# OVERLAND RANCH PORCHVIEW PARK

## SITE PLAN

OVERLAND RANCH PORCHVIEW PARK  
SITE PLAN  
AURORA, CO

SHEET TITLE:  
COVER SHEET

SHEET TITLE:  
 OVERALL  
 UTILITY PLAN

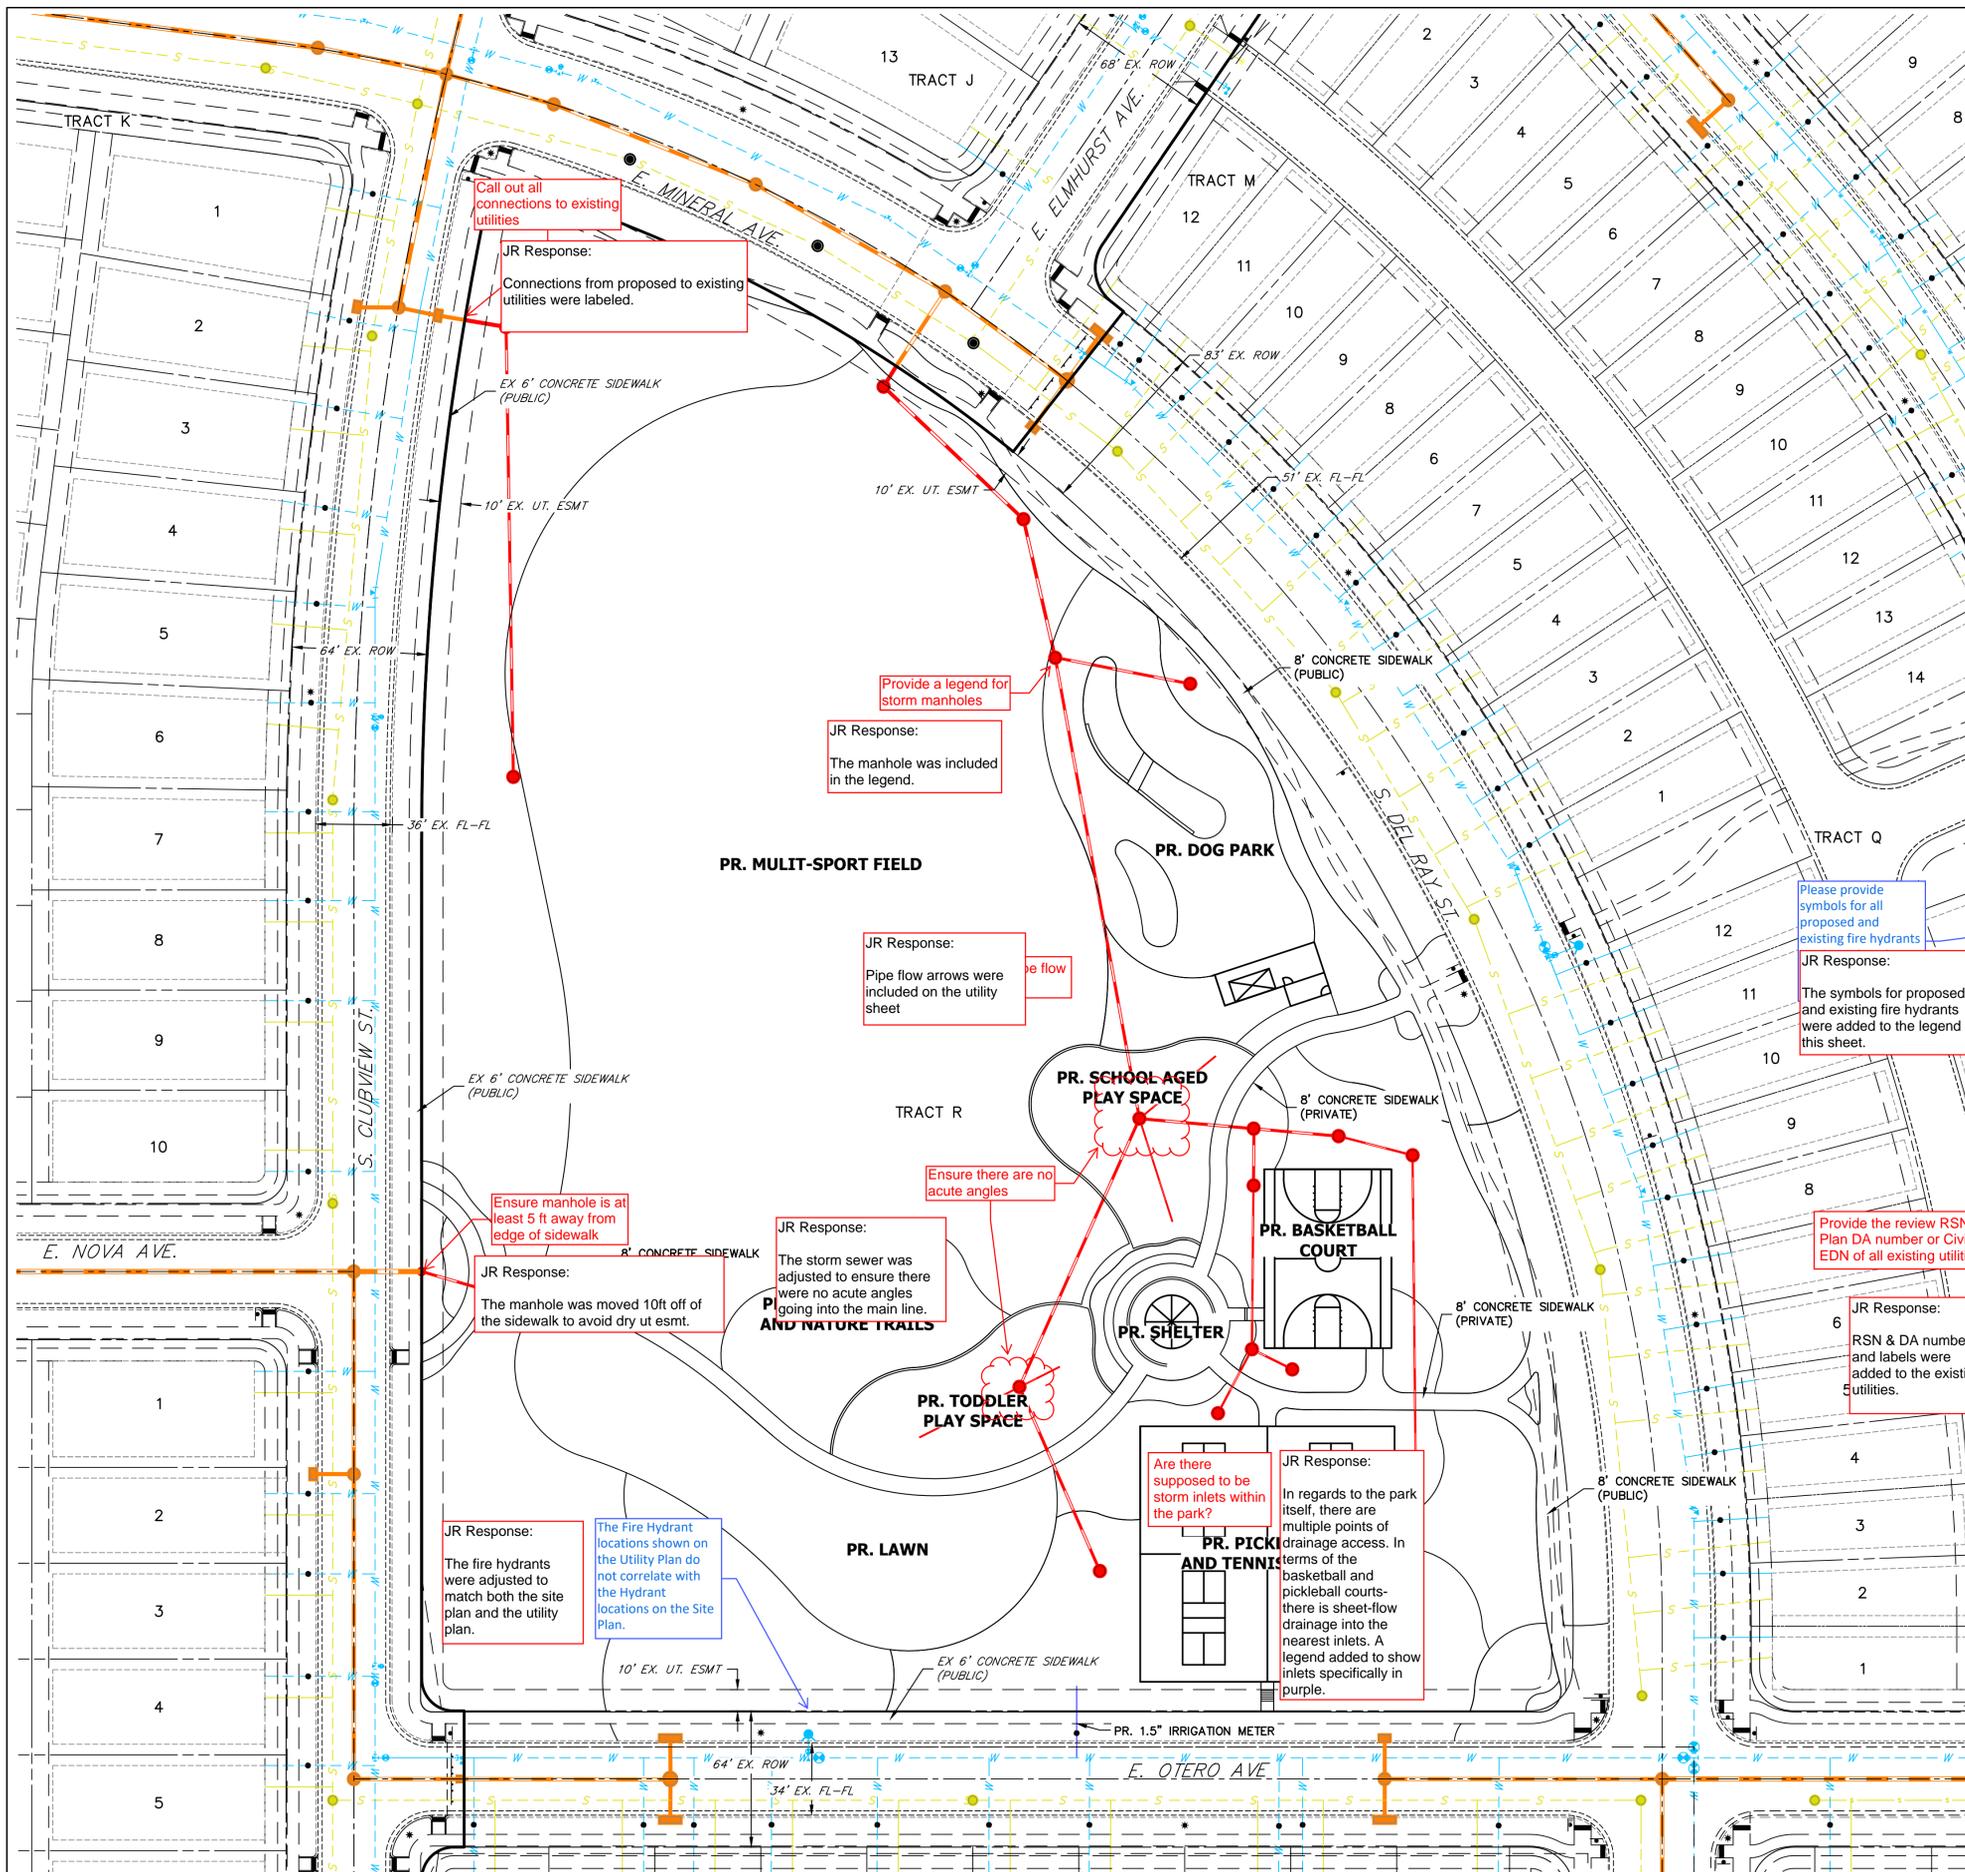
Call out all connections to existing utilities  
 JR Response:  
 Connections from proposed to existing utilities were labeled.

Provide a legend for storm manholes  
 JR Response:  
 The manhole was included in the legend.

Please provide symbols for all proposed and existing fire hydrants  
 JR Response:  
 The symbols for proposed and existing fire hydrants were added to the legend on this sheet.

Ensure manhole is at least 5 ft away from edge of sidewalk  
 JR Response:  
 The manhole was moved 10ft off of the sidewalk to avoid dry ut esmt.

Provide the review RSN, Site Plan DA number or Civil Plan EDN of all existing utilities

The Fire Hydrant locations shown on the Utility Plan do not correlate with the Hydrant locations on the Site Plan.

JR Response:  
 Pipe flow arrows were included on the utility sheet

JR Response:  
 The storm sewer was adjusted to ensure there were no acute angles going into the main line.

JR Response:  
 RSN & DA numbers and labels were added to the existing utilities.

JR Response:  
 The fire hydrants were adjusted to match both the site plan and the utility plan.

SHEET TITLE:  
 GRADING PLAN

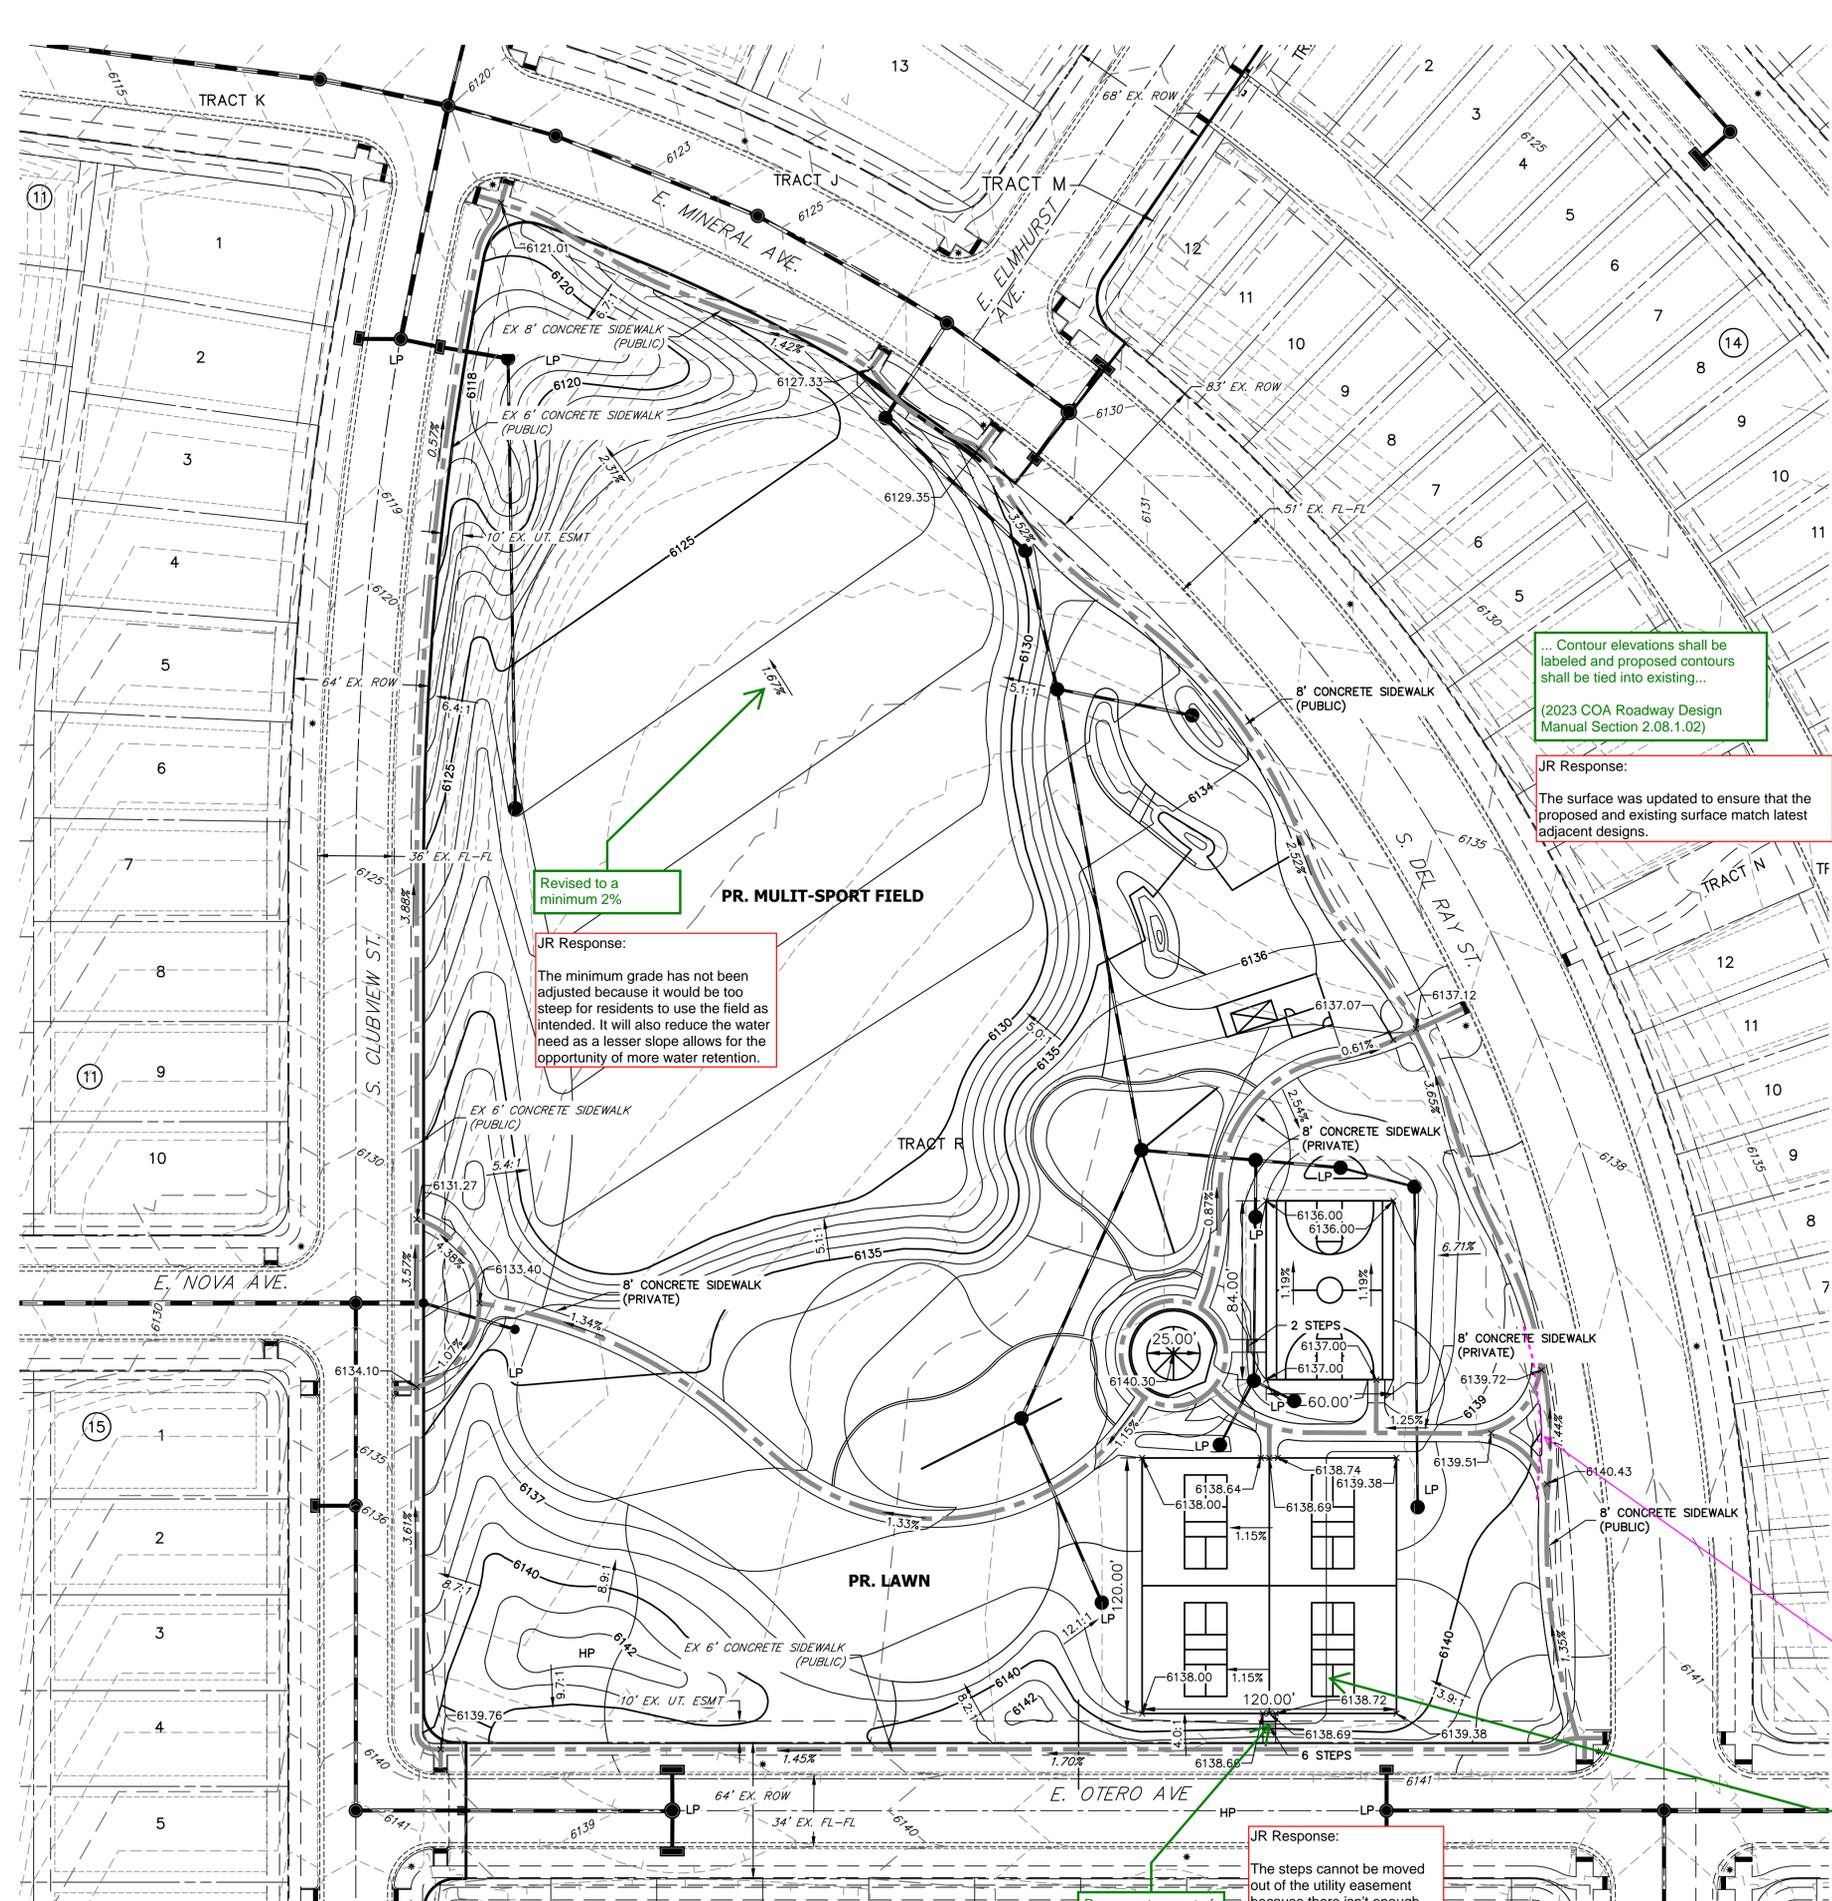
Revised to a minimum 2%  
 JR Response:  
 The minimum grade has not been adjusted because it would be too steep for residents to use the field as intended. It will also reduce the water need as a lesser slope allows for the opportunity of more water retention.

Remove steps out of utility easement.

JR Response:  
 The surface was updated to ensure that the proposed and existing surface match latest adjacent designs.

JR Response:  
 The easement in the sidewalk was adjusted to meet the meandering sidewalk.

JR Response:  
 The steps cannot be moved out of the utility easement because there isn't enough space to move it forward. A license agreement will be created for this instance.

JR Response:  
 Swale linerwork has been added to clarify flow path into inlets.

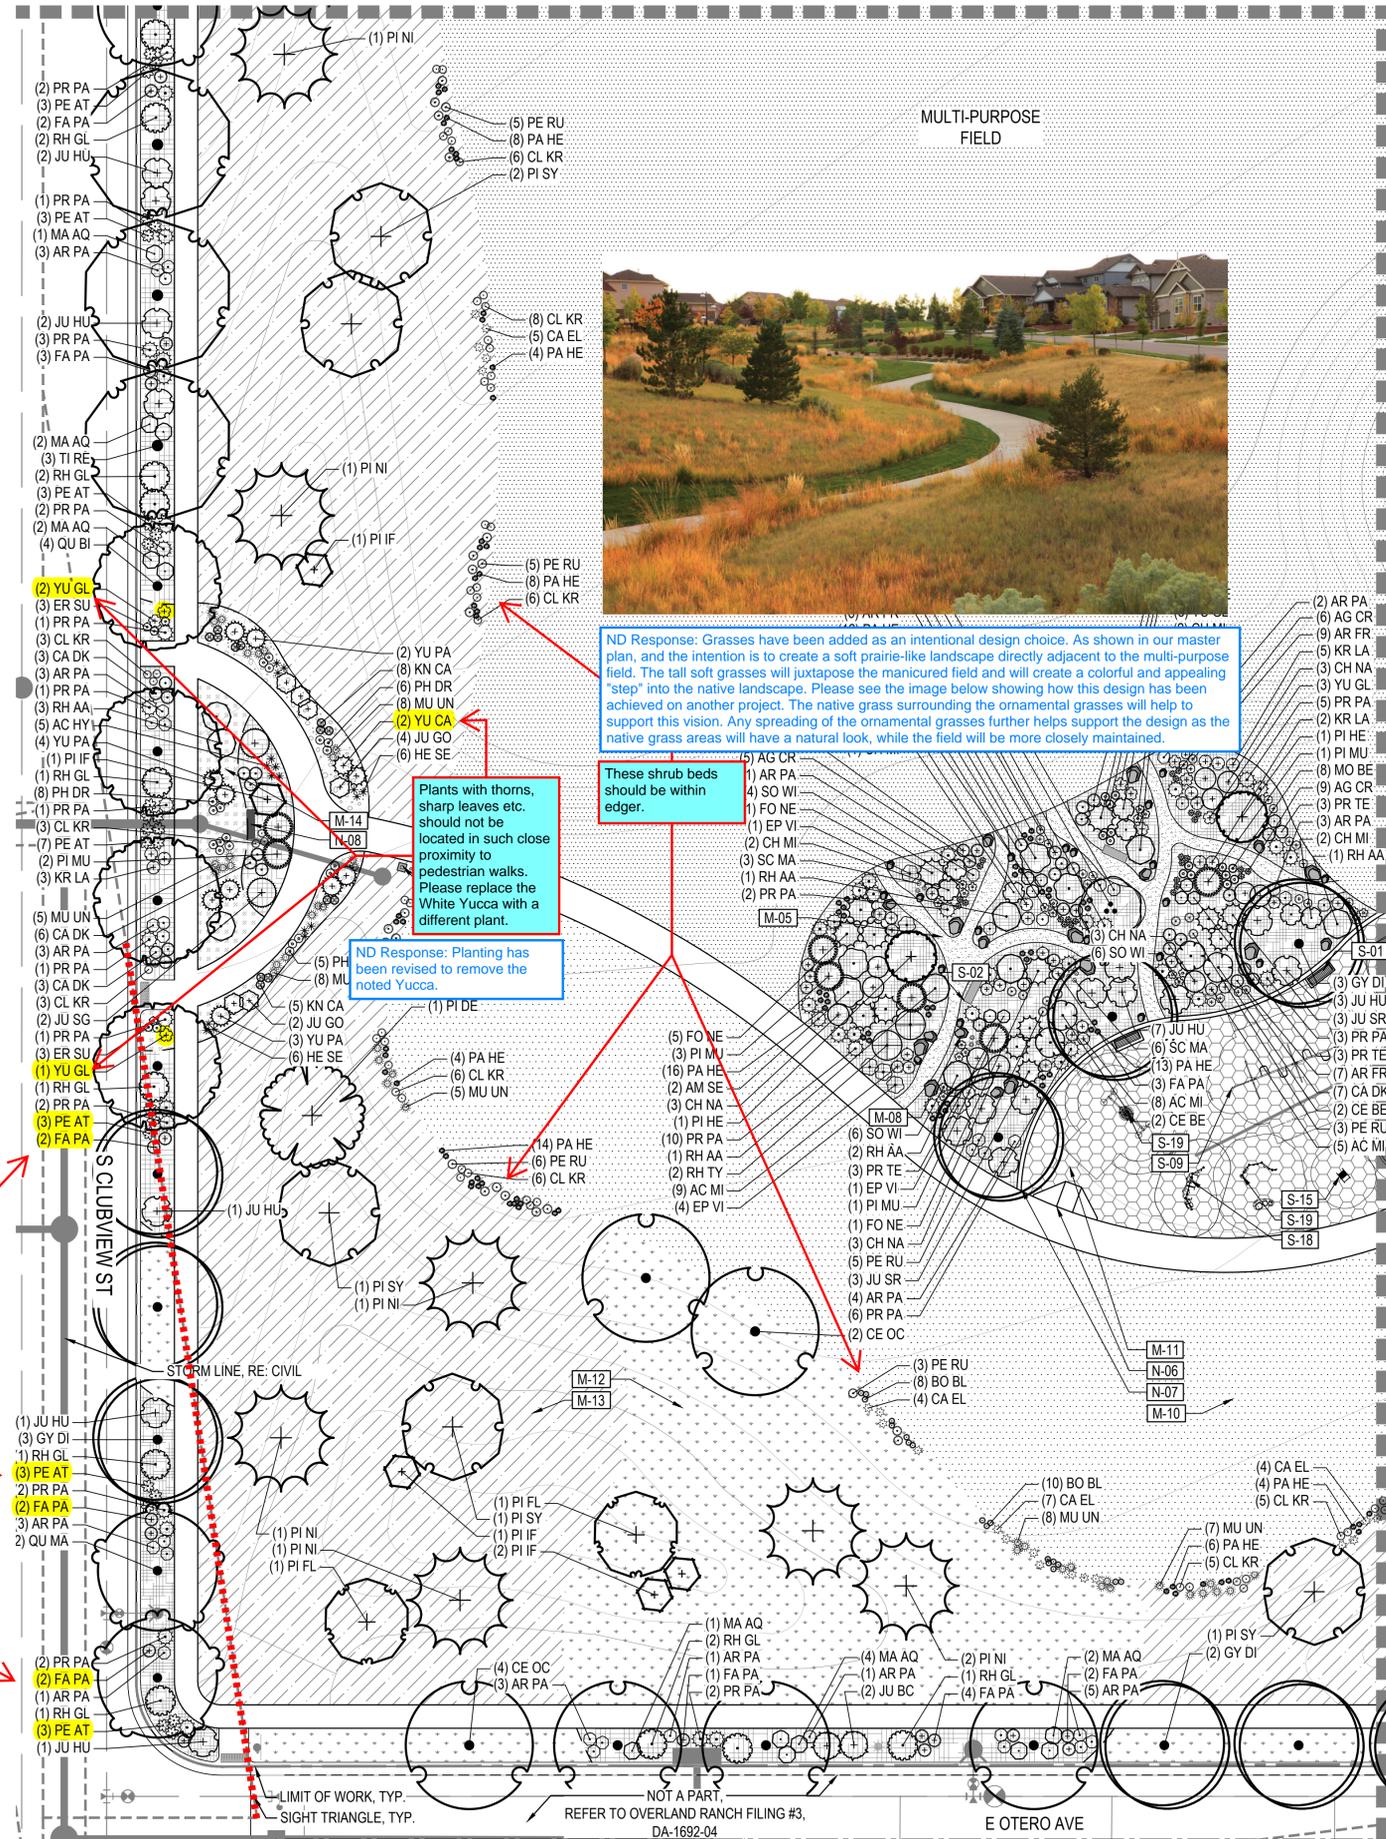
Plants with thorns, sharp leaves etc. should not be located in such close proximity to pedestrian walks. Please replace the White Yucca with a different plant.

The yellow highlighted plants will grow too tall according to Public Works requirements. Must remain 26" or less in height within the designated sight triangle.

ND Response: Grasses have been added as an intentional design choice. As shown in our master plan, and the intention is to create a soft prairie-like landscape directly adjacent to the multi-purpose field. The tall soft grasses will juxtapose the manicured field and will create a colorful and appealing "step" into the native landscape. Please see the image below showing how this design has been achieved on another project. The native grass surrounding the ornamental grasses will help to support this vision. Any spreading of the ornamental grasses further helps support the design as the native grass areas will have a natural look, while the field will be more closely maintained.

ND Response: Planting has been revised to remove the noted Yucca.

ND Response: Planting located in sight triangles has been revised so all plants are 26" or less in height.

5 DOG FENCE & GATE

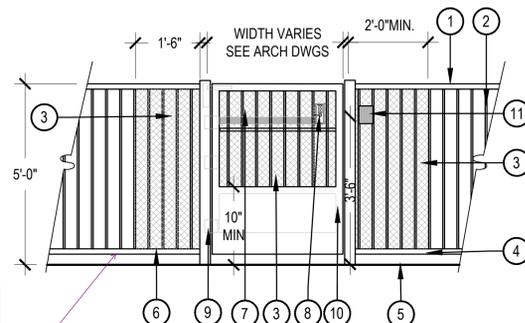
Dogs should not be able to escape from or jump over the dog park fence. Recommend increasing the height of the fence to a minimum of 6' for security purposes.  
ND Response: 5' Height for dog fence is preferred and should suit the needs of a neighborhood dog park well. Thank you.
